ARAPAHO ROAD - PHASE III

FROM SURVEYOR BOULEVARD TO ADDISON ROAD

PROJECT RECORD COPY I

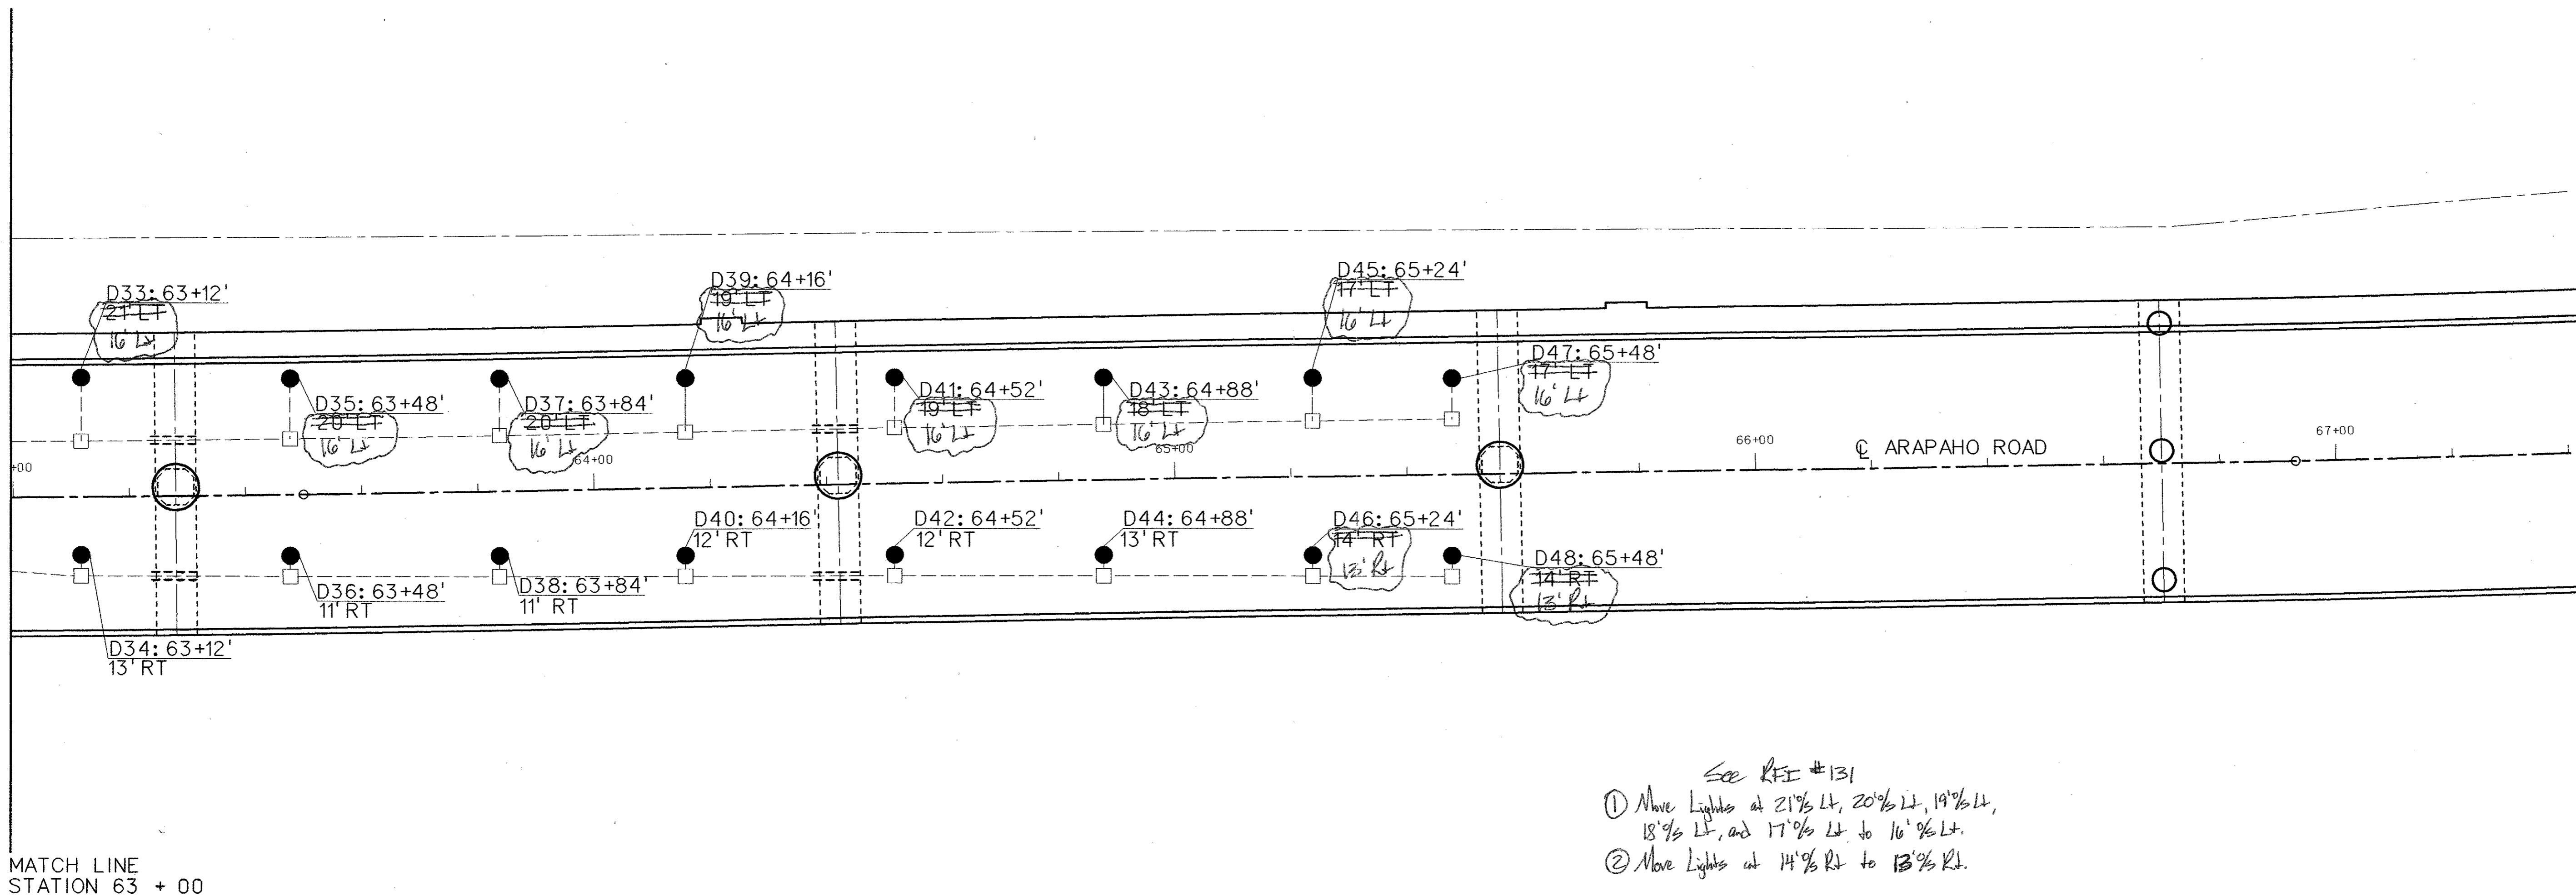
See REF #131
 ① Move Lights at 21' LT, 20' LT, 19' LT, 18' LT, and 17' LT to 16' LT.
 ② Move Lights at 14' RT to 13' RT.

ROADWAY LIGHT POLE & RECEPTACLE DETAIL

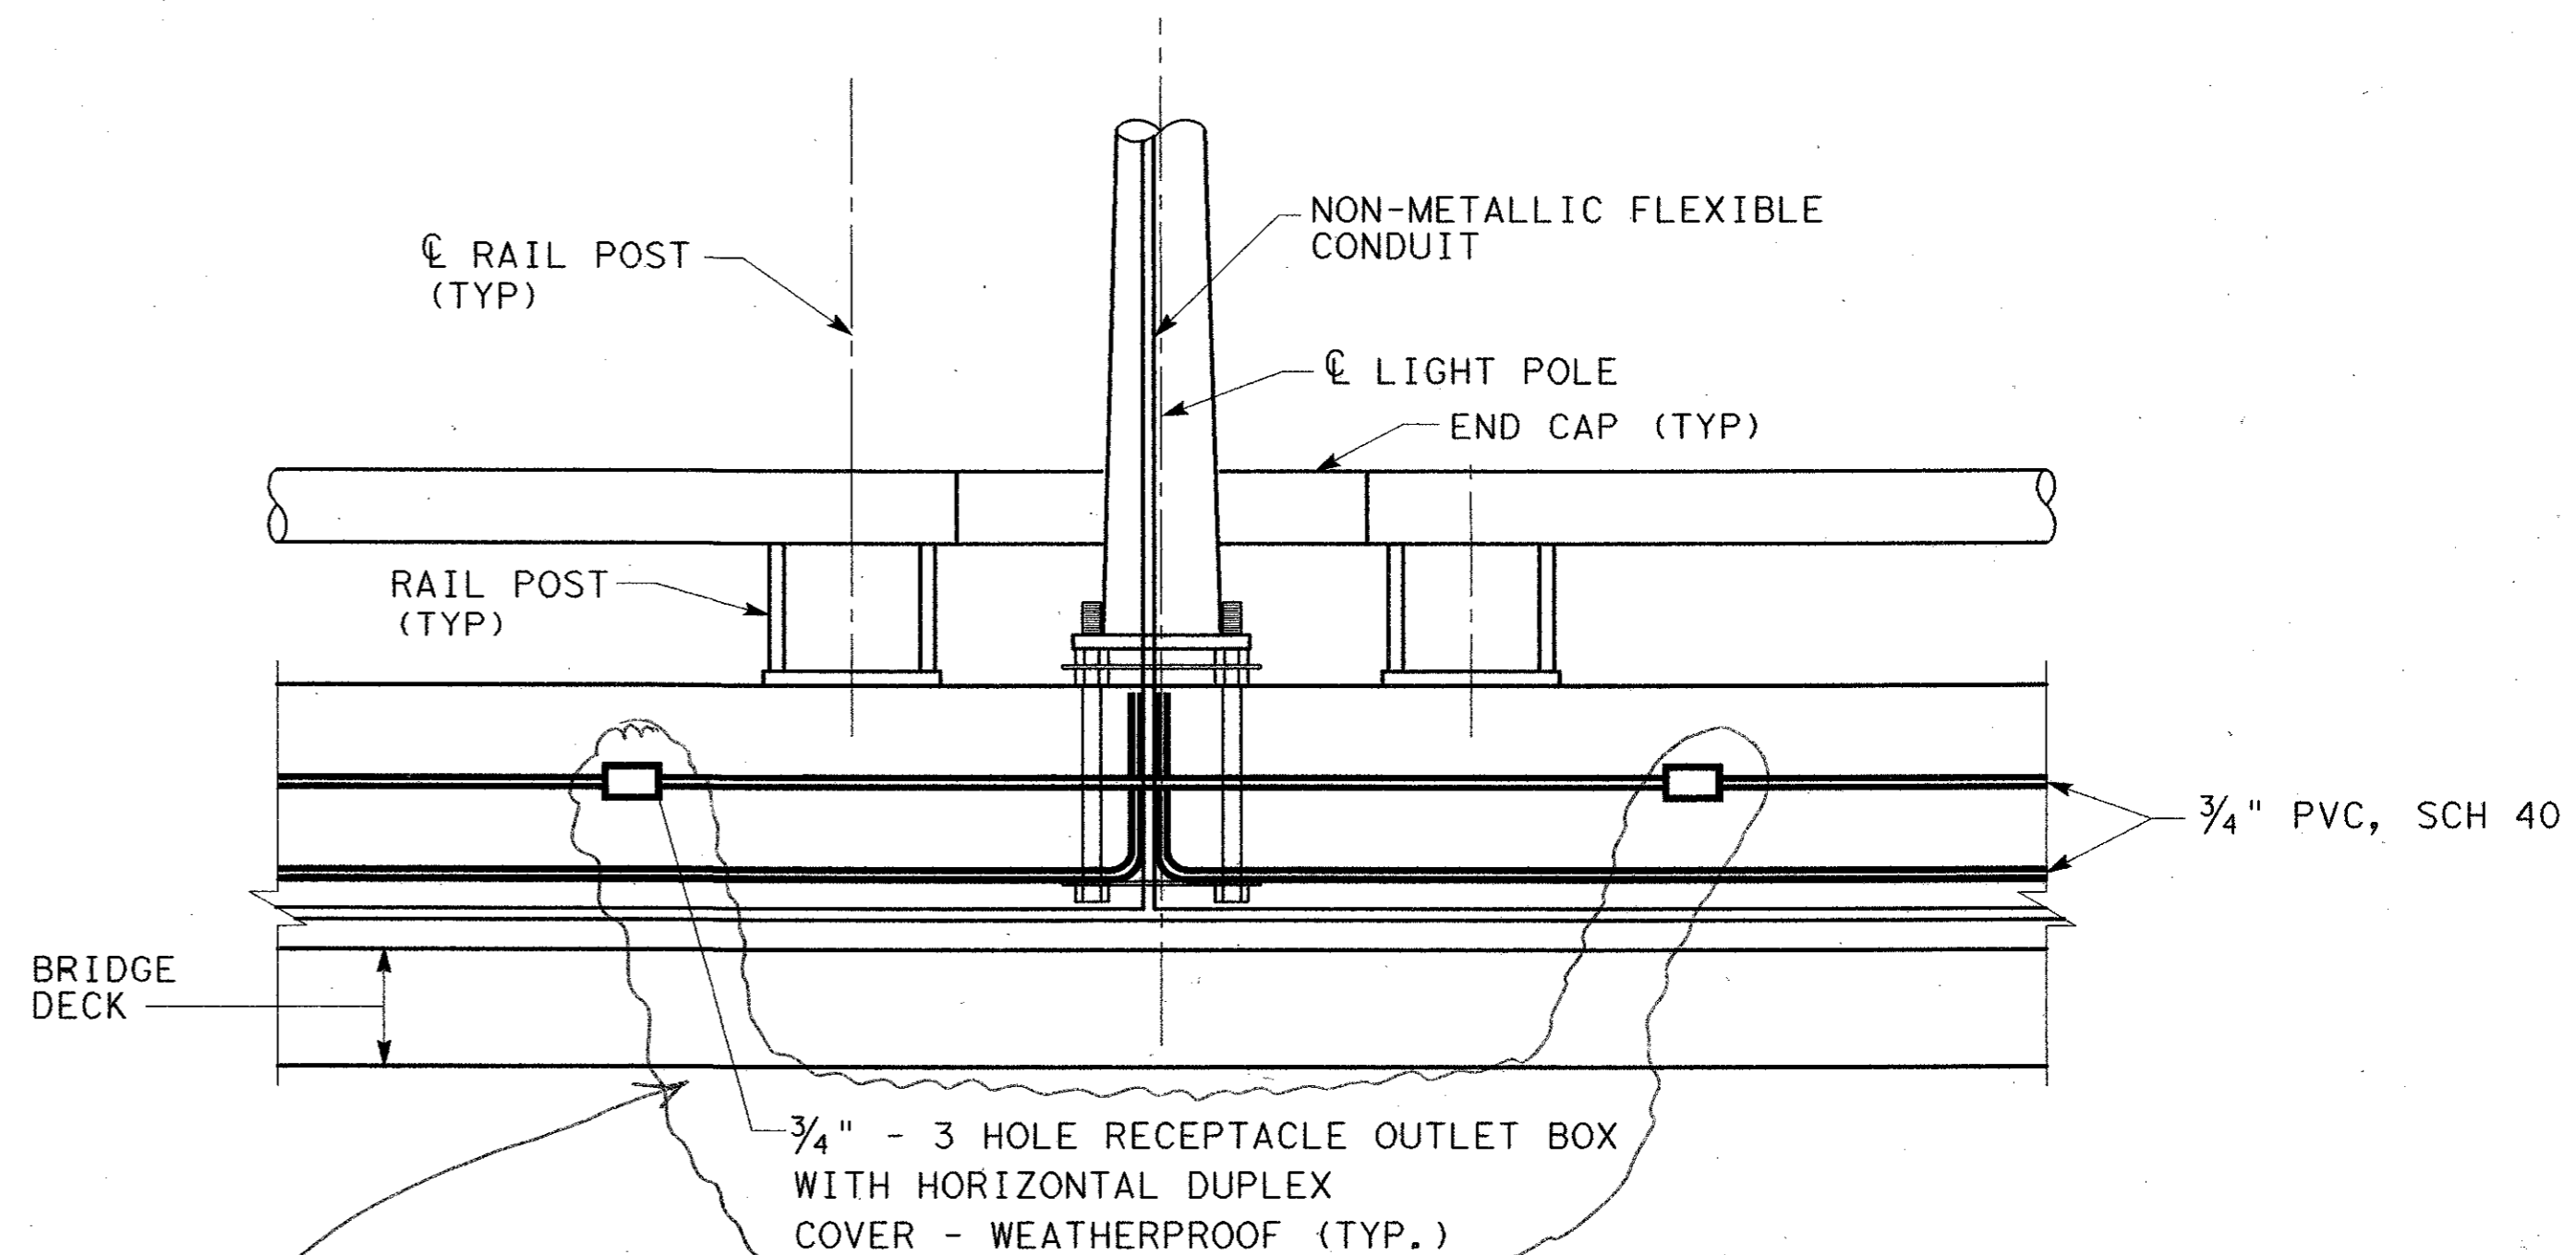
See REF # 0101
The receptacle outlet boxes will be recessed into the concrete rail and flush mounted.
